Technical Service Bulletin

Subject: FUEL-FILLER LID PANEL IS DEFORMED	Bulletin No.: 09-019/21
	Last Issued : 12/02/2021

2019-2021 Mazda3
2020-2021 CX-30

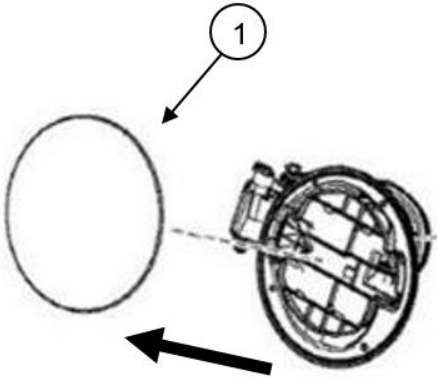
Some vehicles may exhibit a deformed fuel-filler lid panel (1) attached to the fuel-filler lid box, resulting in a poor appearance.

This concern is caused by the lid box not having enough water drainage capability which leads to the accumulation of water inside it. The water then freezes in cold weather and expands or the inner side of the lid panel absorbs the water and swells from long exposure, deforming the lid panel. To eliminate this concern, the shape of the fuel-filler lid box has been modified to have better drainage capability and a modified fuel-filler lid panel service part has been established for less water absorbance.

1. Verify customer concern.
2. Replace the fuel-filler lid panel (1) with a modified one according to the instructions on MGSS.
 - Mazda3 (FUEL-FILLER LID REMOVAL/INSTALLATION)
 - CX-30 (FUEL-FILLER LID REMOVAL/INSTALLATION)

**NOTE:**

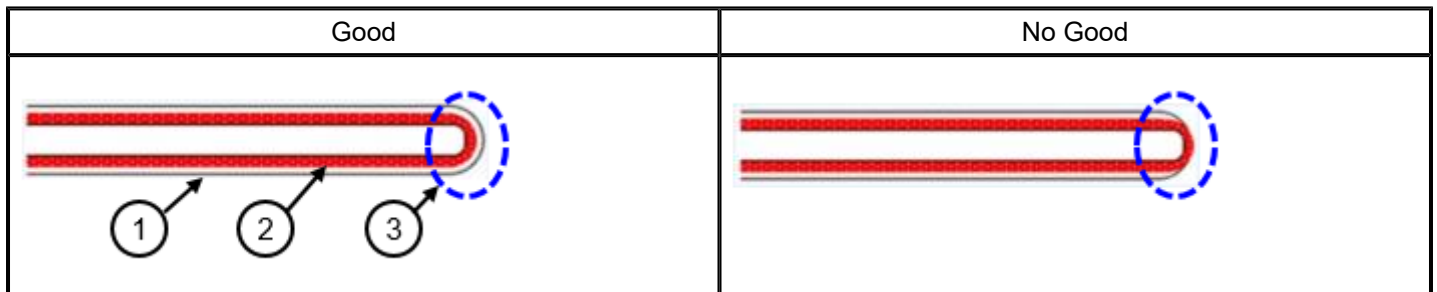
- It is not necessary to remove primer on fuel filler lid before refinish painting.
- Apply clear paint (1) enough to cover the base paint (2) at the edge (3) of the fuel-filler lid panel.
- Avoid excess paint at the edge (3)
